HISTORIC AND DESIGN REVIEW COMMISSION

November 15, 2017

HDRC CASE NO: 2017-569
ADDRESS: 7615 KENNEDY HILL
LEGAL DESCRIPTION: NCB 10879 BLK 13 LOT 1 (BCB UT-20A & 20D)
ZONING: C-3 H
CITY COUNCIL DIST.: 3
DISTRICT: Brooks School of Aerospace Medicine Historic District
APPLICANT: ACM Hub LLC
OWNER: UIW Medical Facility
TYPE OF WORK: Installation of eight foot tall perforated screen
APPLICATION RECEIVED: October 25, 2017
60-DAY REVIEW: December 24, 2017

The applicant is requesting a Certificate of Appropriateness for approval to install an eight foot tall perforated screen around existing mechanical chillers

A.1

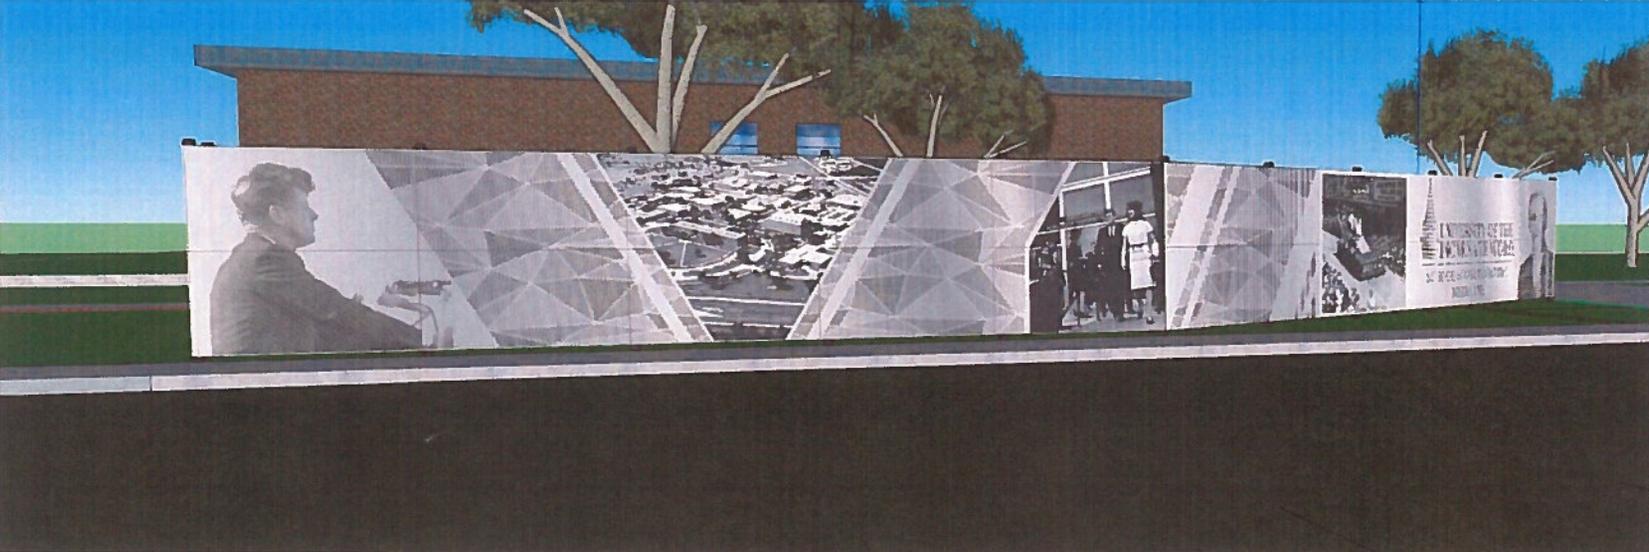
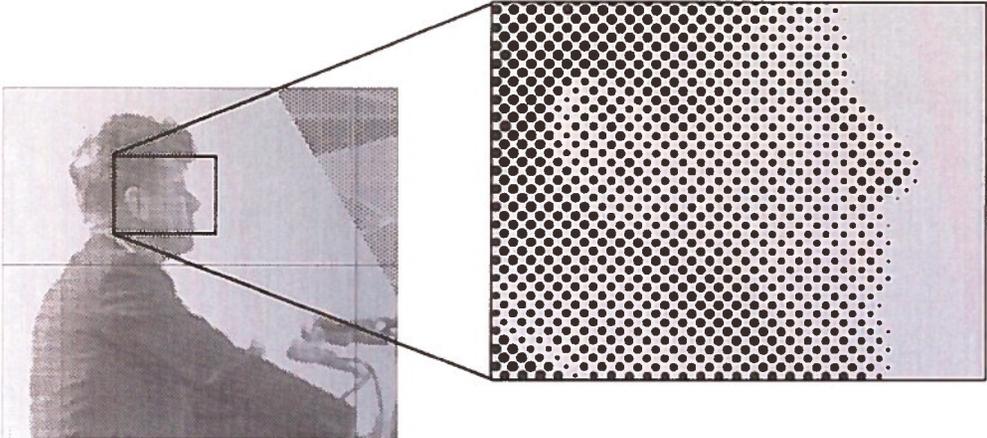
- c. MATERIAL - The proposed screening is to be constructed of perforated aluminum panels measuring ¼" in thickness. Each individual panel will measure four feet in width. The design of each panel will follow a pattern, with every third, fourth, or fifth panel featuring a perforated photo panel depending on location, and all others featuring a perforated geometric graphic. The photo panels will contain imagery of John F. Kennedy Jr., the historic School of Aerospace Medicine campus, or the University of the Incarnate Word School of Osteopathic Medicine logo. According to District Design Guideline 5.A.7, screen walls around equipment and trash containers should be constructed of terra-cotta colored brick in patterns found on the historic campus. Staff finds that the proposed material could be appropriate with the integration of brick to conform with the Guidelines, but does not find the proposal in conformance as submitted.

- d. HEIGHT - The proposed screening measures eight feet in height. According to UDC Sec. 35-514(c), the maximum height allowed for fencing for school facilities is eight feet. Staff finds the proposed height consistent with the UDC.

- i. That the applicant integrates terra-cotta colored brick in patterns found on the historic campus as noted in finding c. The applicant must submit final drawings to staff for review and approval.
- ii. That the fence complies with School of Aerospace Medicine Historic District standards and is a maximum height of eight (8) feet. The final construction height of an approved fence may not exceed the maximum height as approved by the HDRC at any portion of the fence. Additionally, all fences must be permitted and meet the development standards outlined in UDC Section 35-514.
